REMARKS/ARGUMENTS

Annotated Sheet Showing Changes

Fig.1
Prior Art

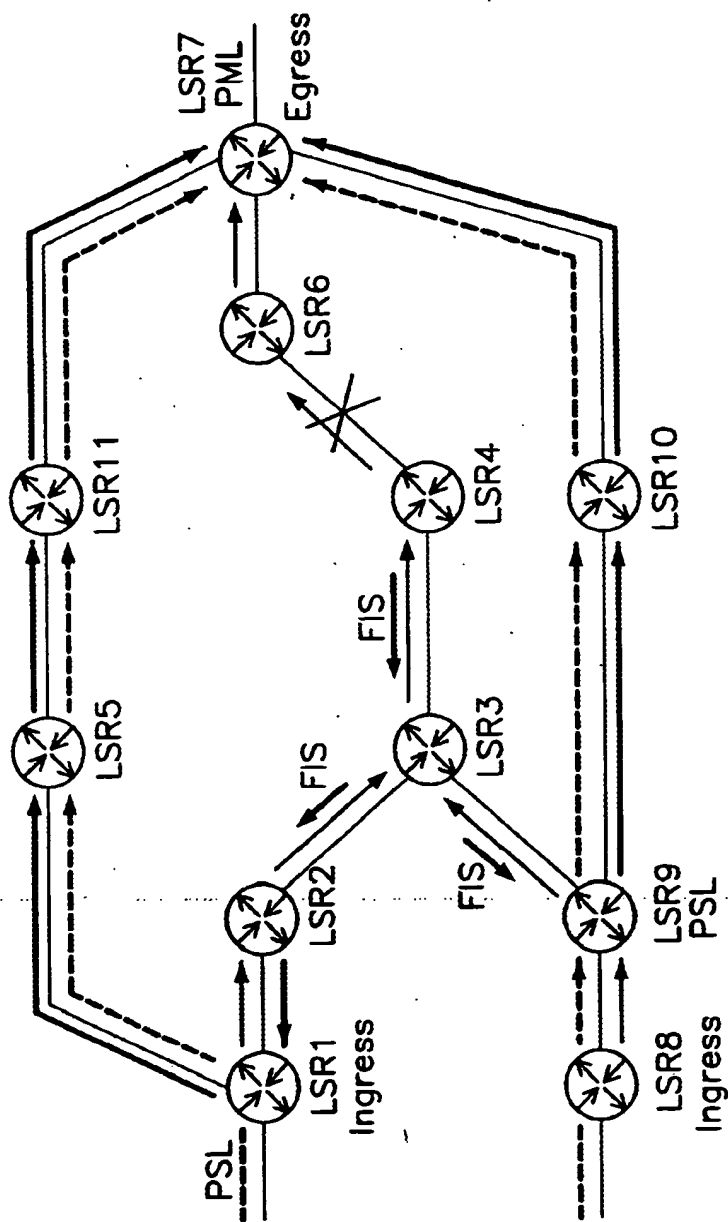
In the Office Action, the drawings are objected to as containing informalities. In particular, Figures 1 and 2 are objected to as lacking legends identifying them as prior art, and Figure 3 is objected to as including the legend "Reverss".

Applicants respectfully traverse the rejection. Figures 1 and 2 are amended herein to include legends identifying them as prior art. Figure 3 is amended herein to replace "Reverss" with "Reverse".
